Subject: **Palo Verde Nuclear Generating Station  
Units 1, 2, and 3  
Docket Nos. STN 50-528, 529, and 530  
Response to Request for Additional Information (RAI) -  
Request for Relief from the American Society of Mechanical  
Engineers (ASME) Code, Section XI, Reactor Vessel Head  
Flange Seal Leak Detection Piping - Relief Request 49**

**APS Response to NRC Request for Additional Information  
(RAI) - Relief Request 49**

**Request for Relief from the American Society of Mechanical  
Engineers (ASME) Code, Section XI, Reactor Vessel Head  
Flange Seal Leak Detection Piping**

**Piping and Instrumentation Diagram (P&ID) and Piping Isometric Drawing  
RPV Flange Seal Leak Detection Piping**

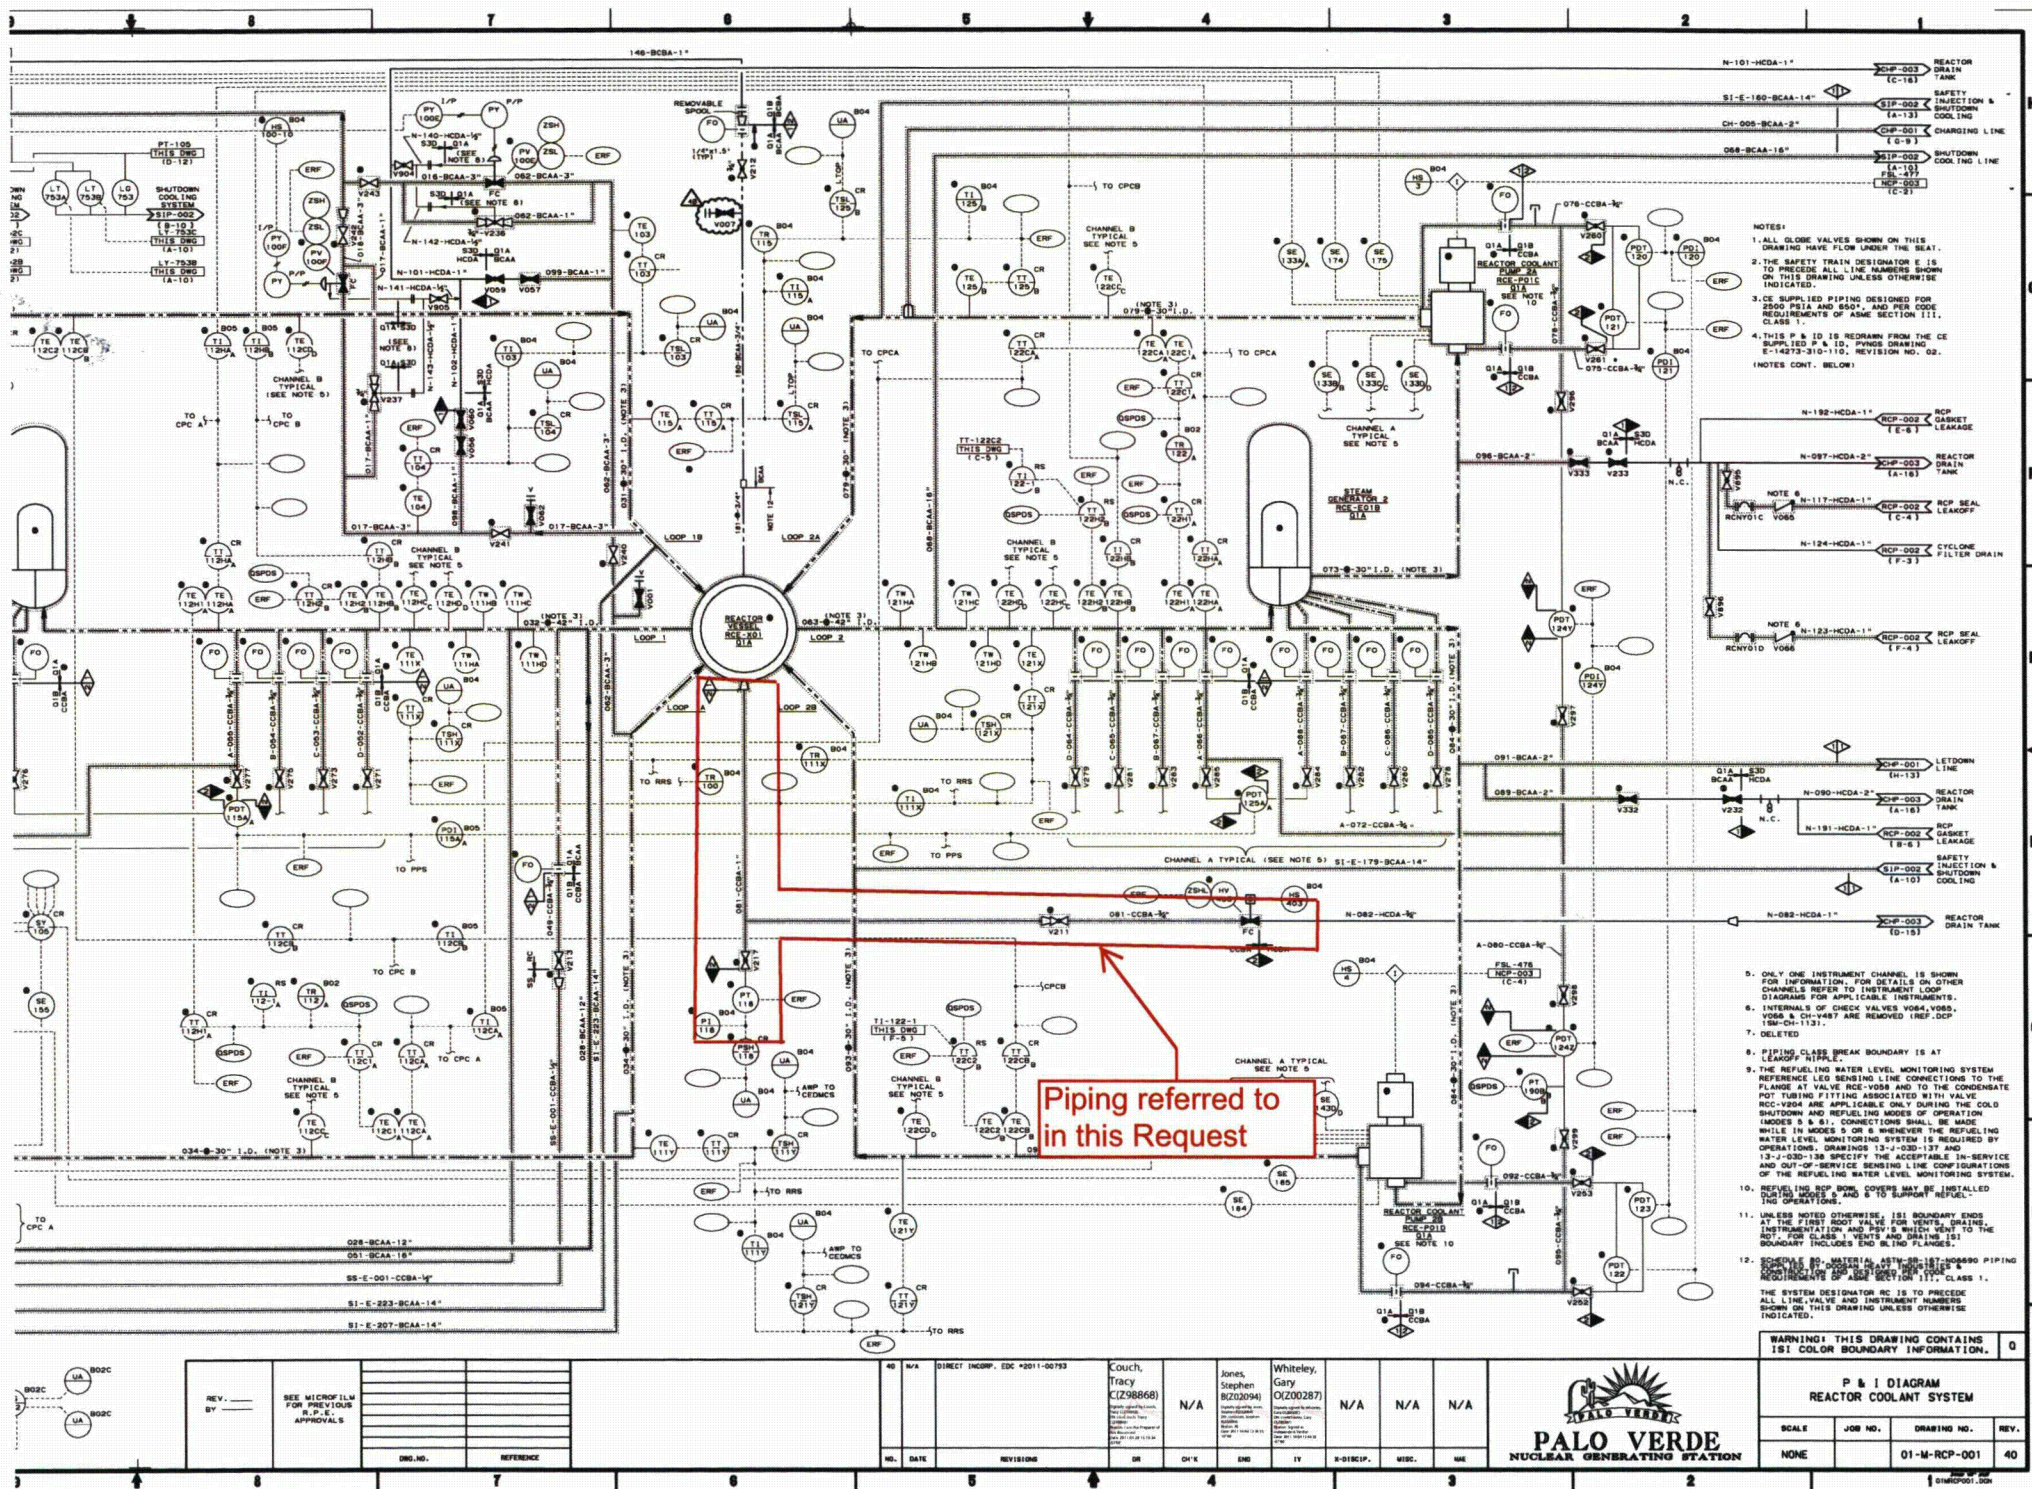
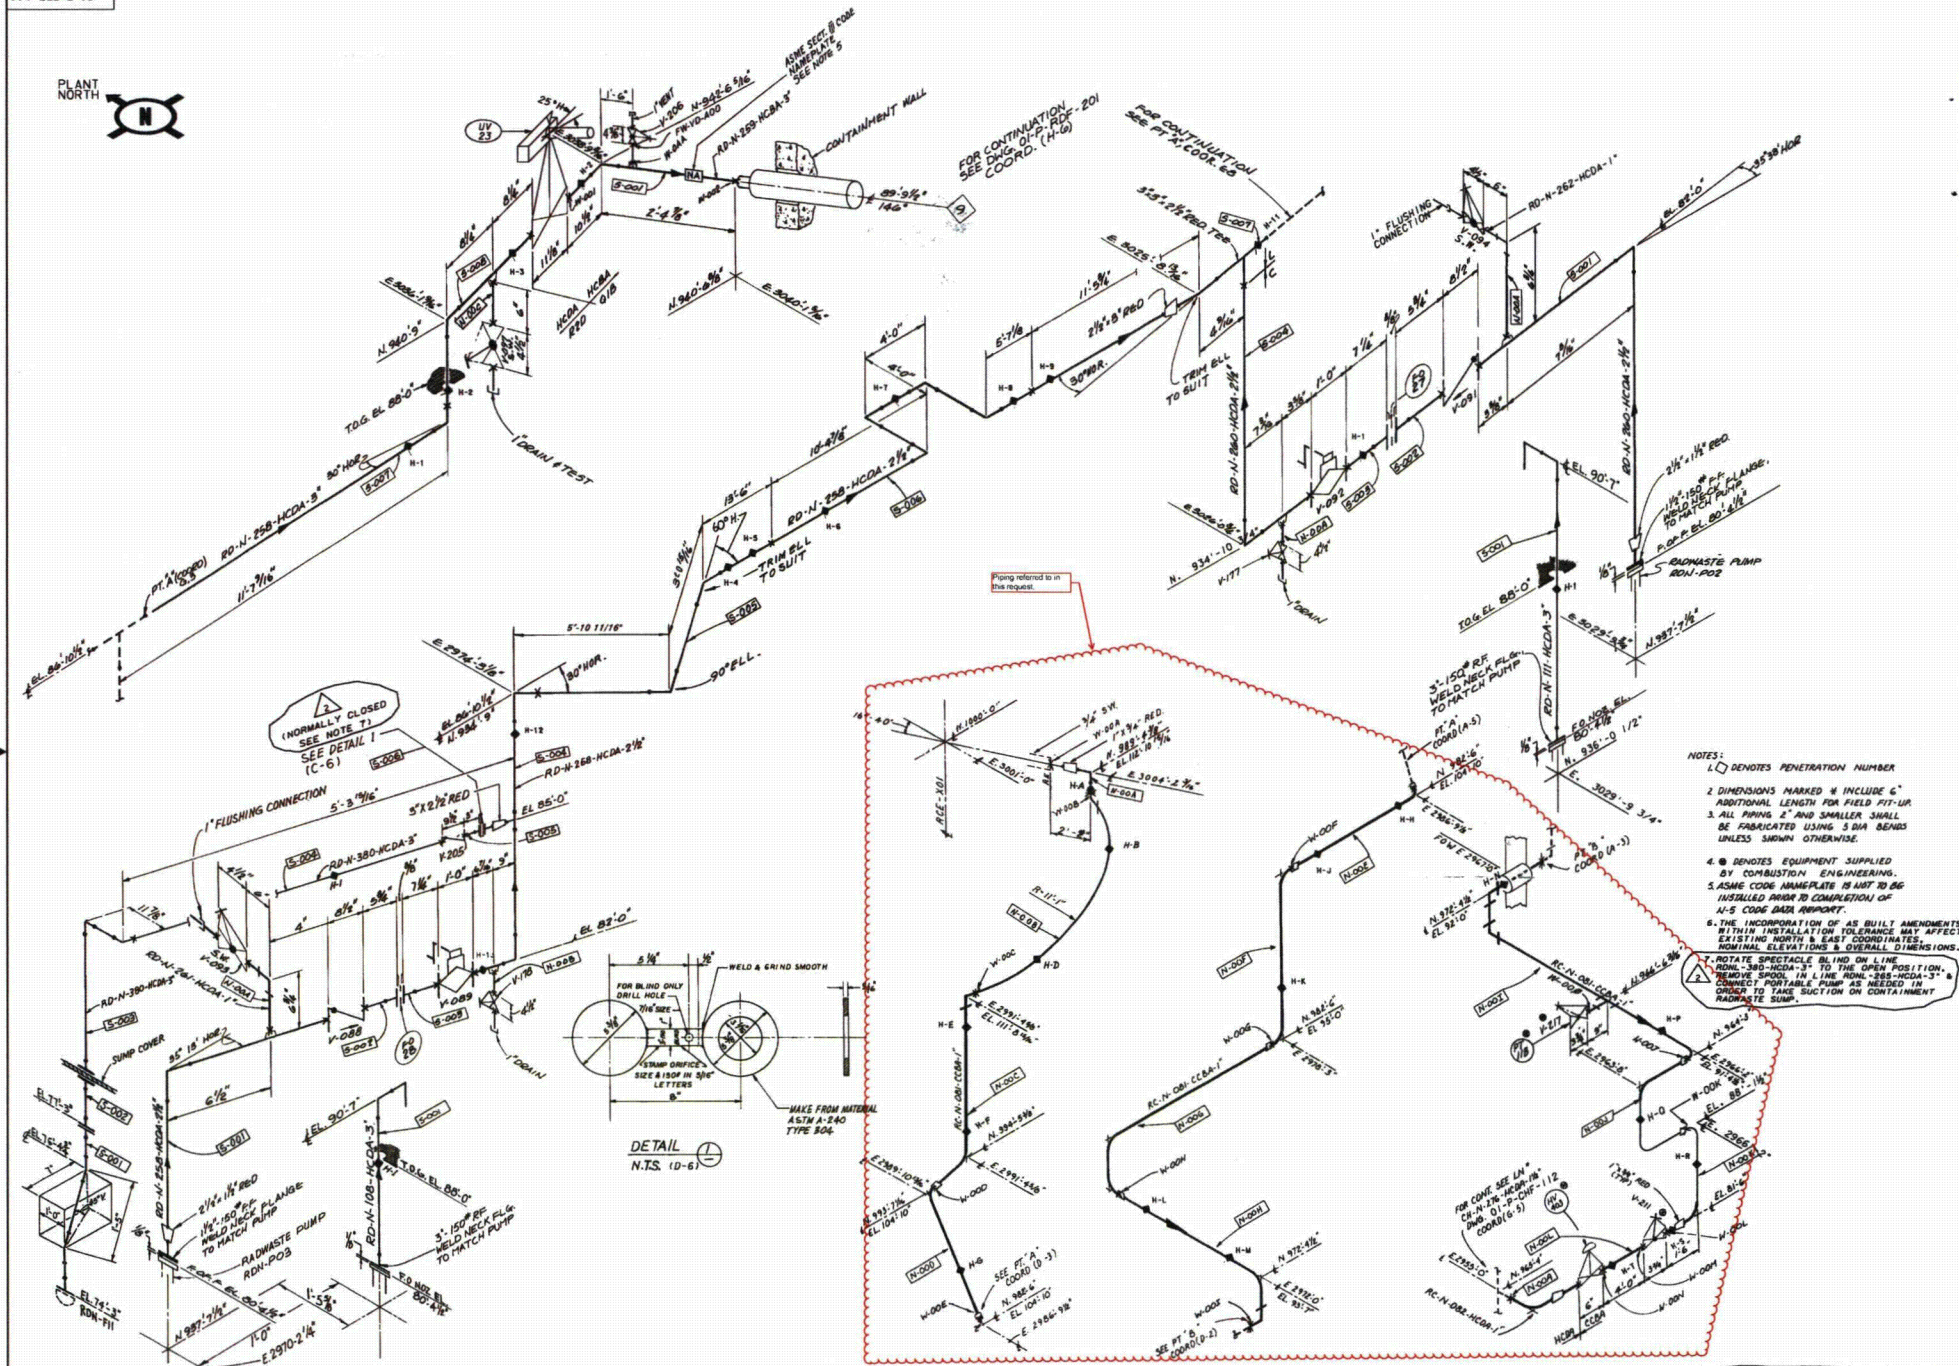
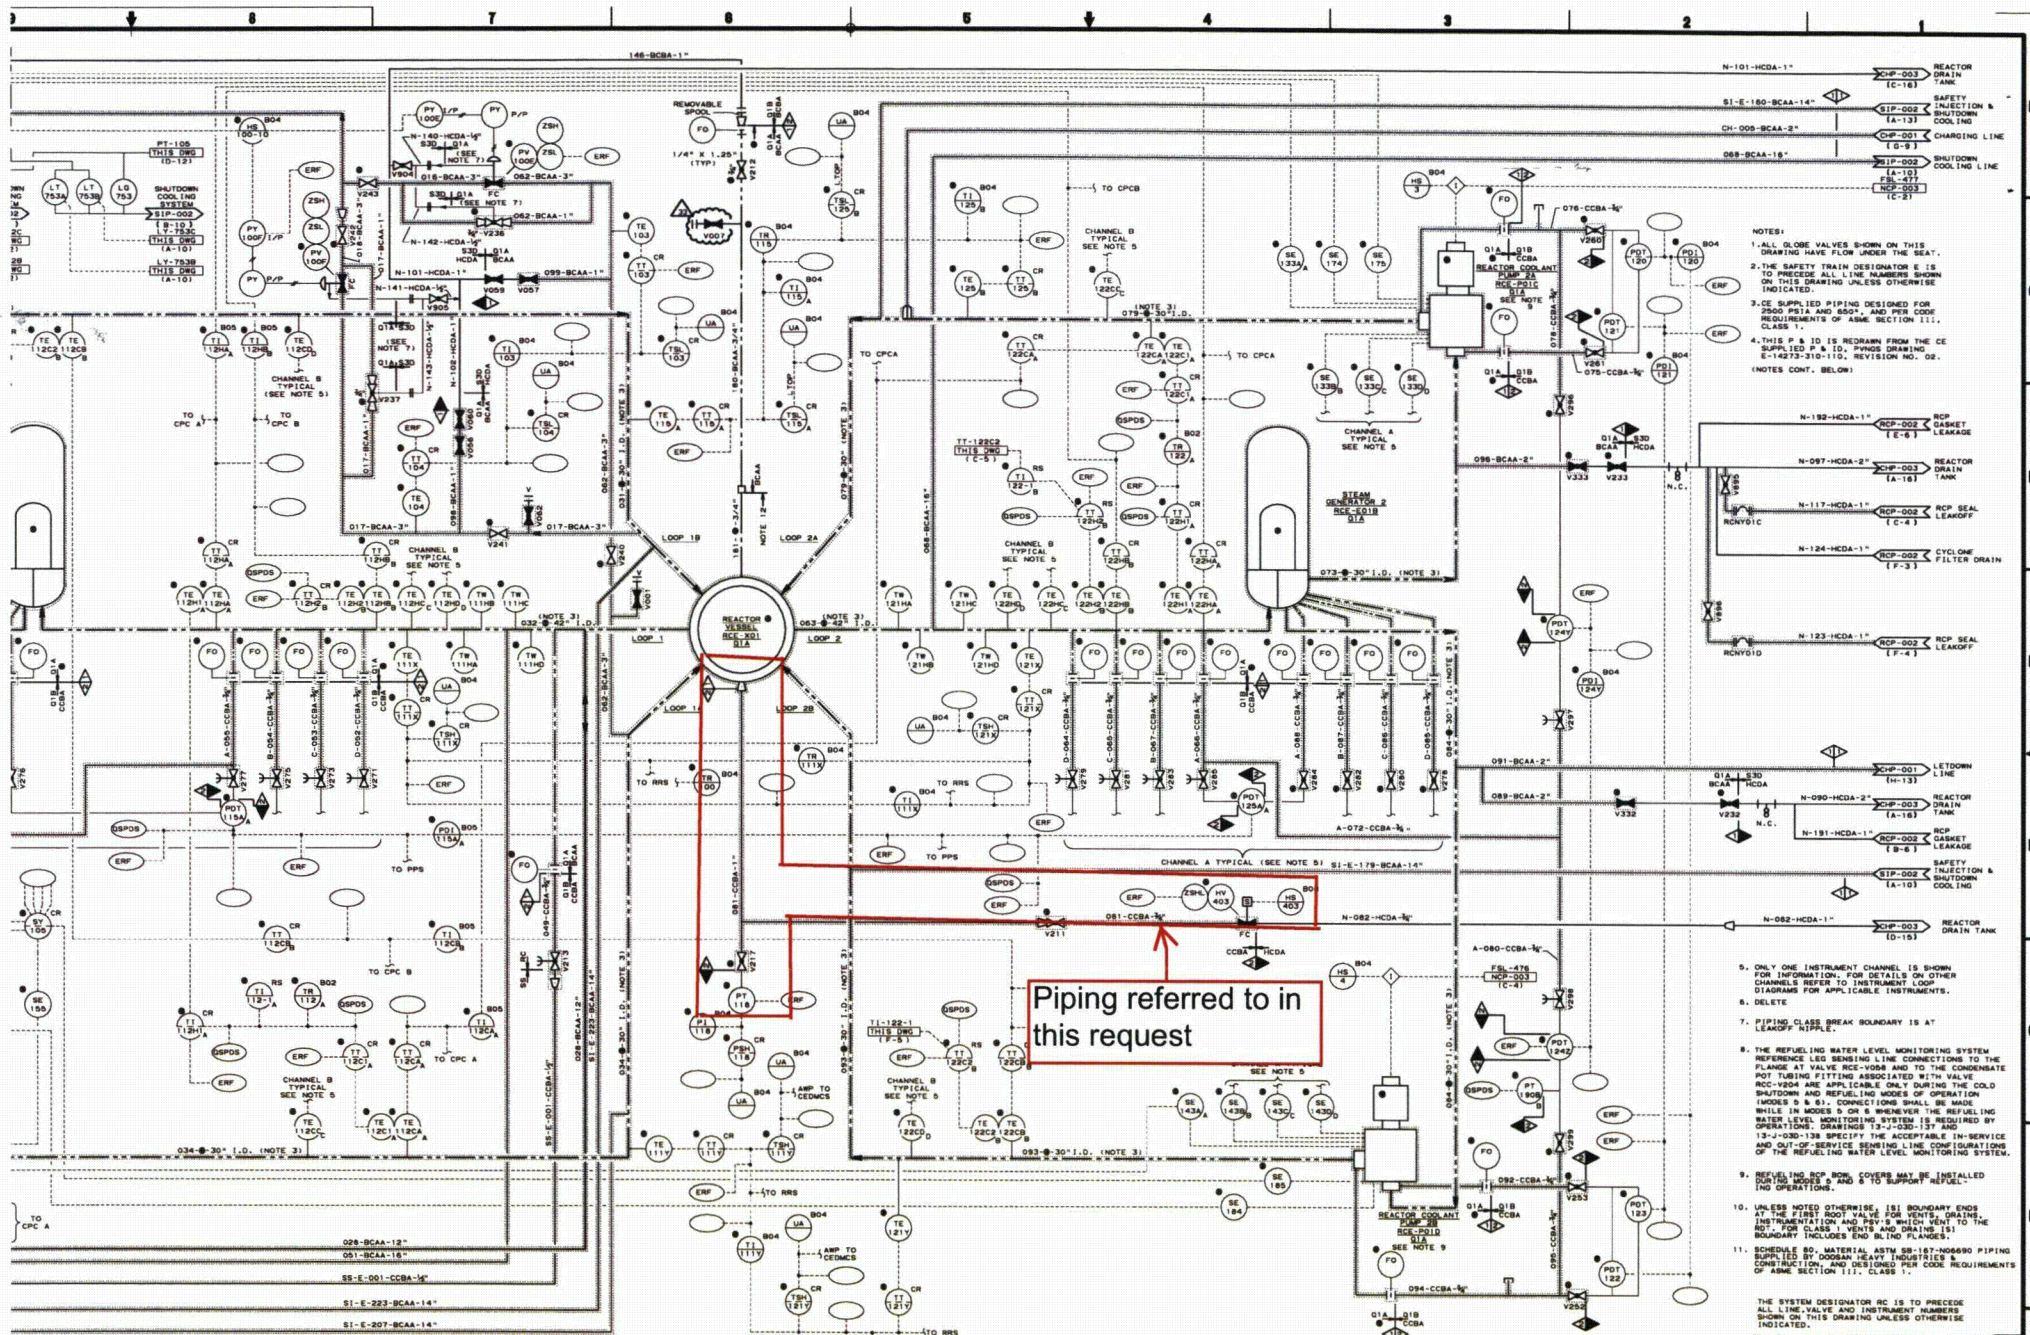
Provide a piping and instrumentation diagram (P&ID) and a piping isometric drawing showing the RPV flange seal leak detection piping.

The requested piping and instrumentation diagram (P&ID) and the piping isometric drawing showing the RPV flange seal leak detection piping is provided as Attachment 1 of this Enclosure.
